**CITY OF PORTLAND, MAINE
DEVELOPMENT REVIEW APPLICATION
PLANNING DEPARTMENT PROCESSING FORM**

PLANNING BOARD REPORT #38-98

Major Site Plan Application
I&R Associates, Riverside Industrial Parkway

RE: Site Plan Review
I & R Associates
Riverside Industrial Parkway

EROSION AND SEDIMENTATION CONTROL PLAN

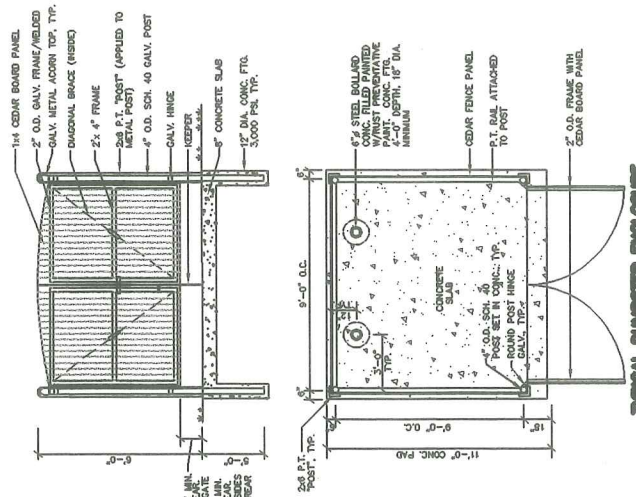
9. The discussion for erosion control measures is very vague. Please provide the detail sheet that outlines the erosion control requirements.
10. In an effort to promote water quality, recommend that the bottom of the detention basin be lowered by 2' to create a permanent pond.

Items 9, 10 in my previous correspondence dated August 4, 1998 have been satisfactorily revised. There are no further comments.

SHEET 1 OF 2

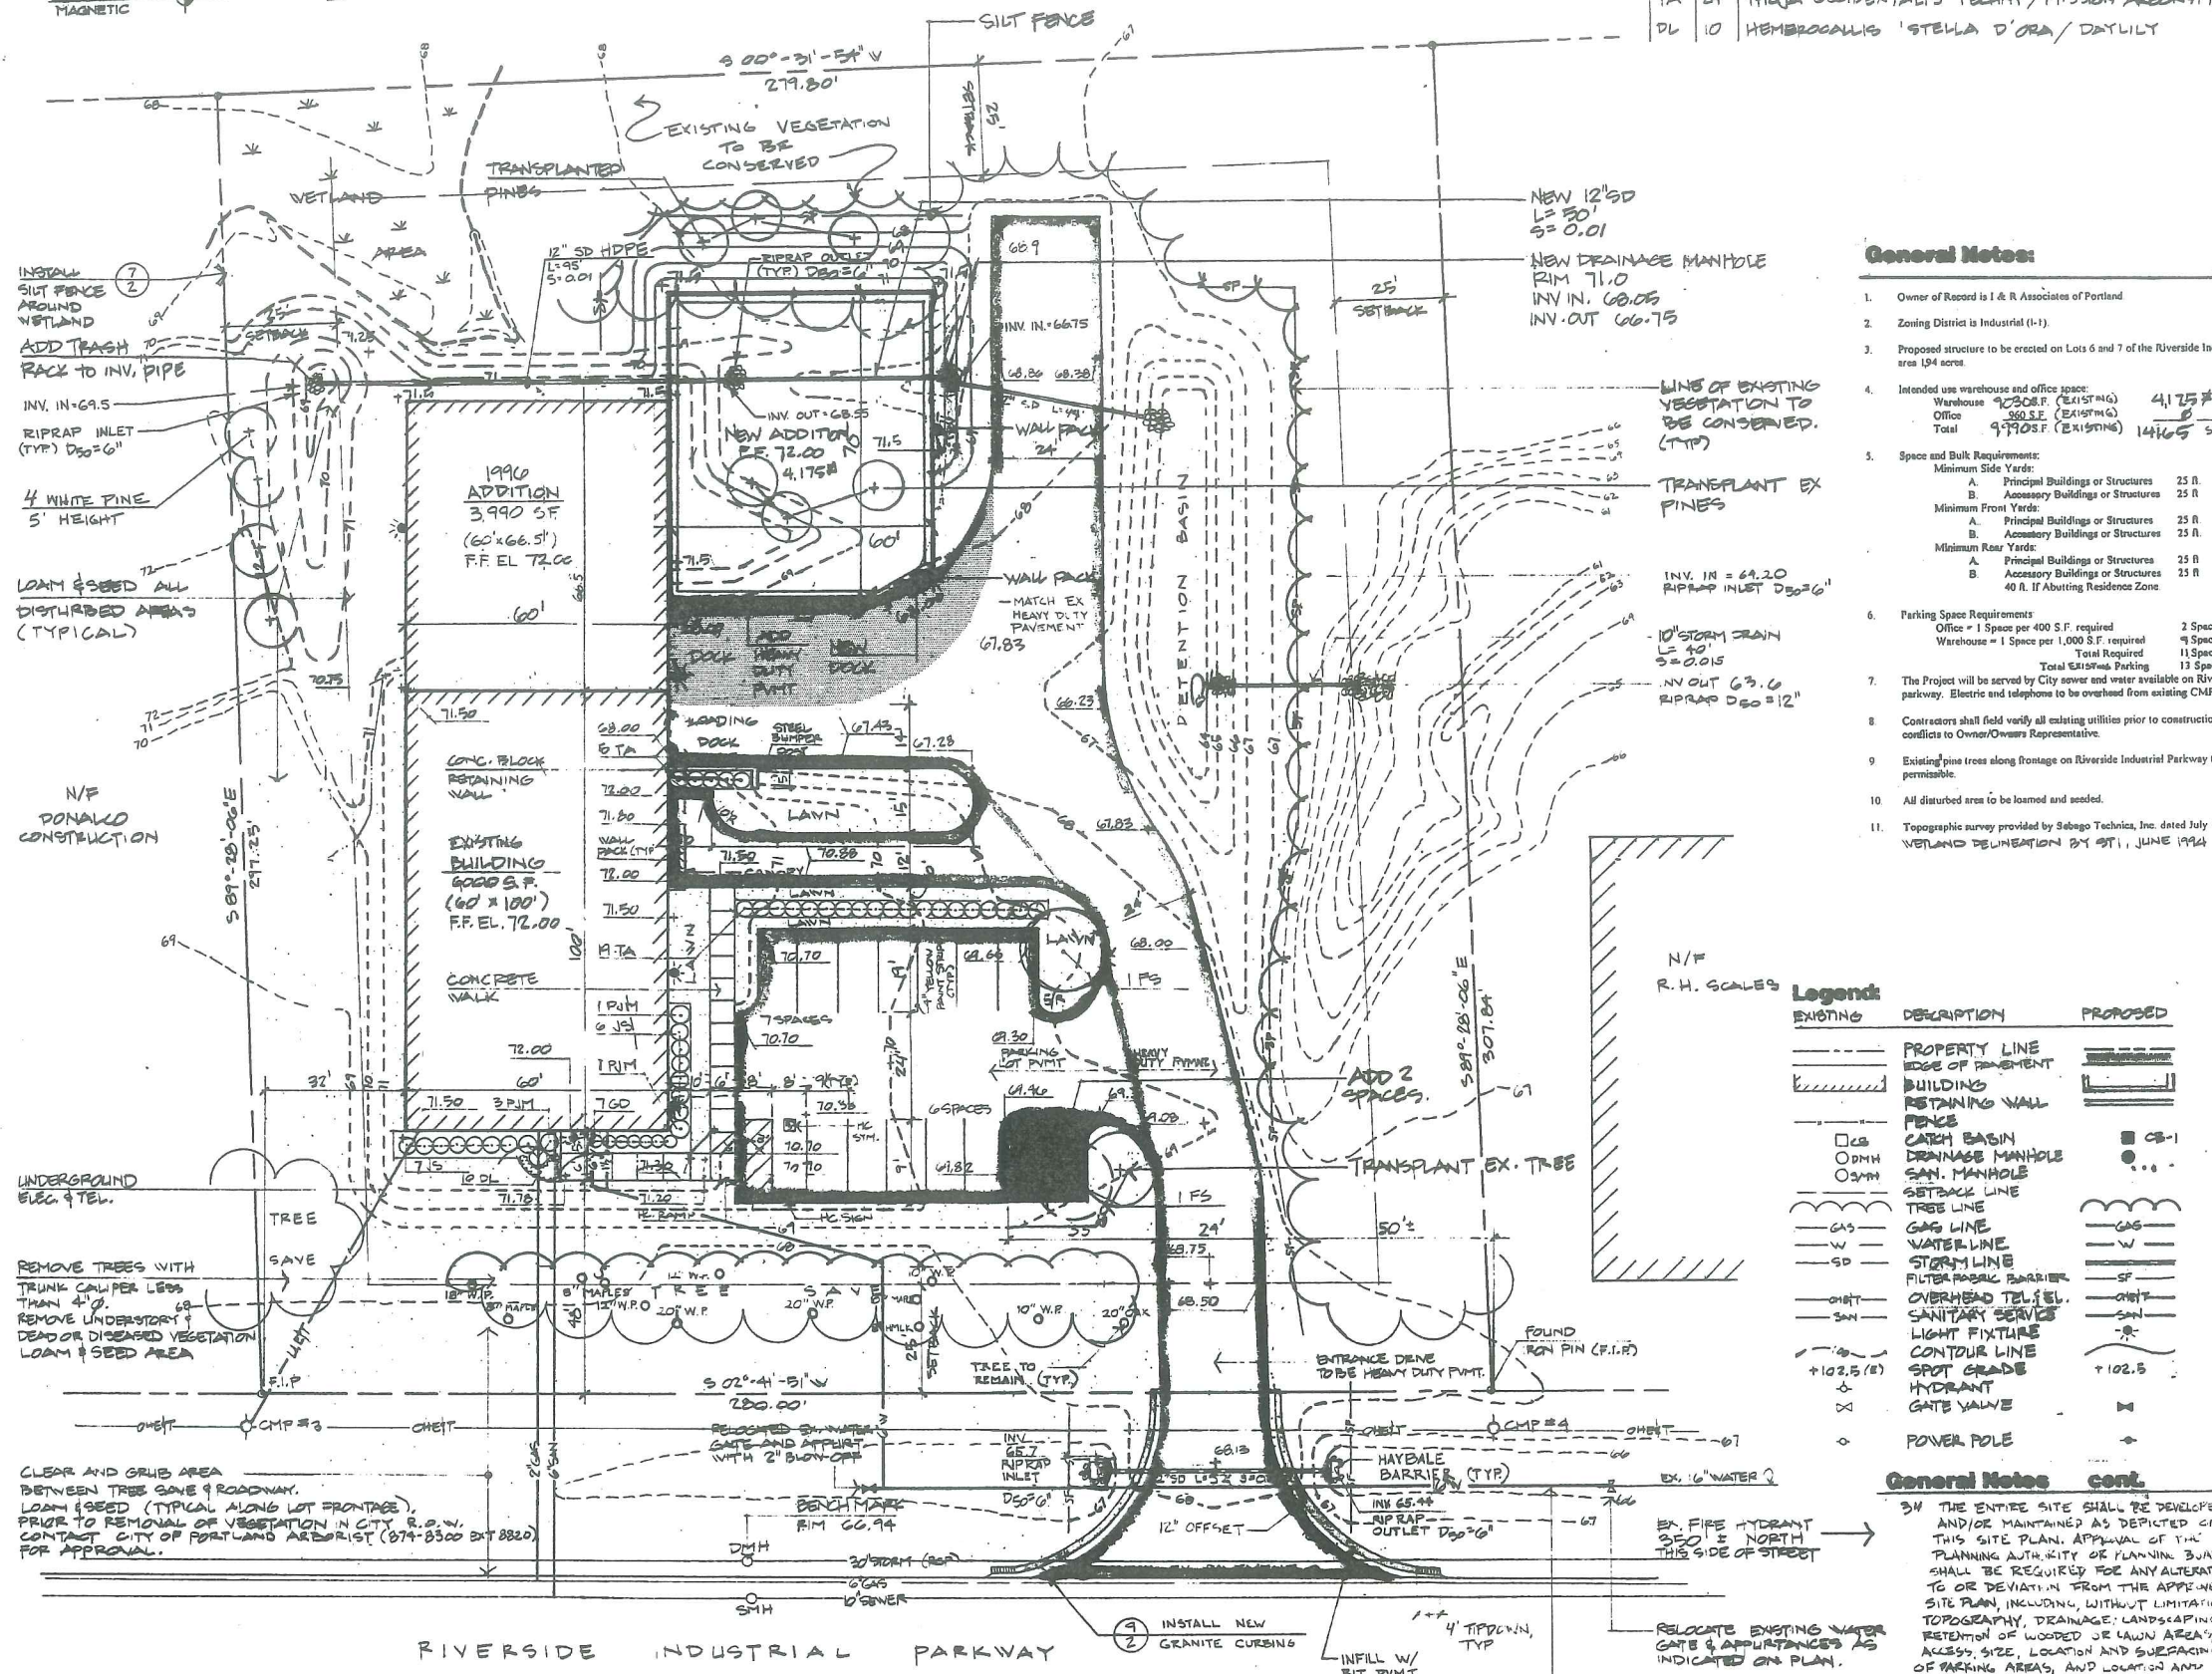
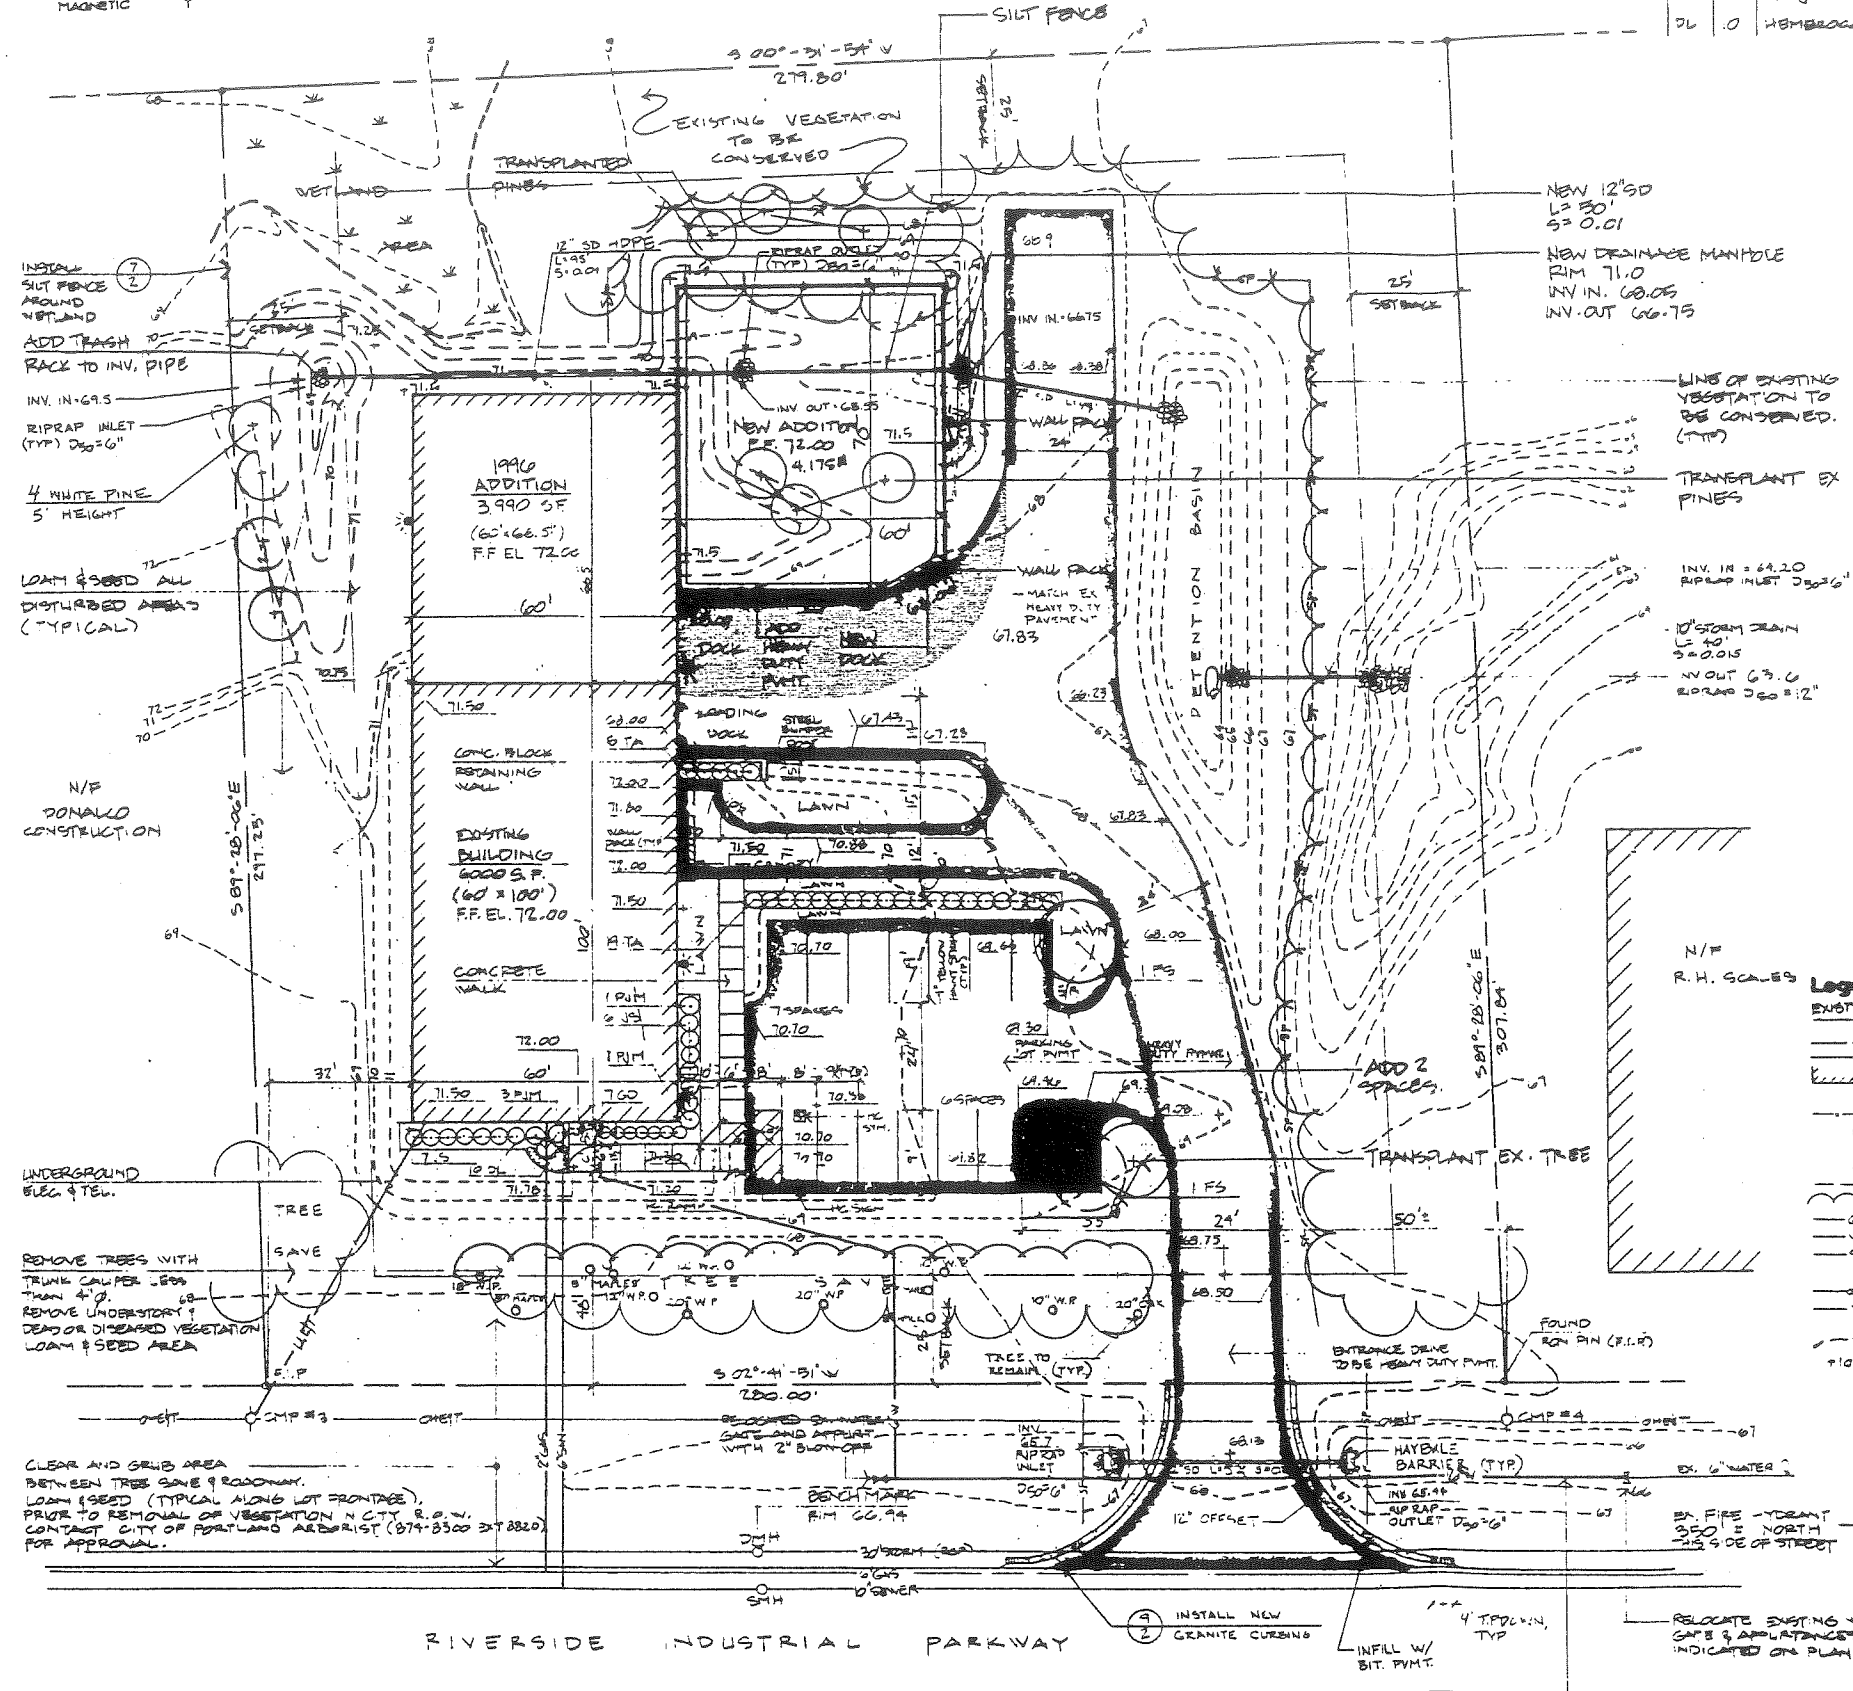
8. The existing roof has a ridge that splits the width of the building. Please provide a plan of the proposed building expansion that shows the new location of the ridge line for watershed 11. This watershed would not have the identical output for the present and post conditions. There should also be a shallow concentrated flow component for the T_c calculation.

Items 1-8, 11 noted in my previous correspondence dated August 4, 1998 have been satisfactorily revised. However, the submission package received did not include a revised site plan; therefore review of responses for items 9 and 10 of the referenced correspondence was not possible.
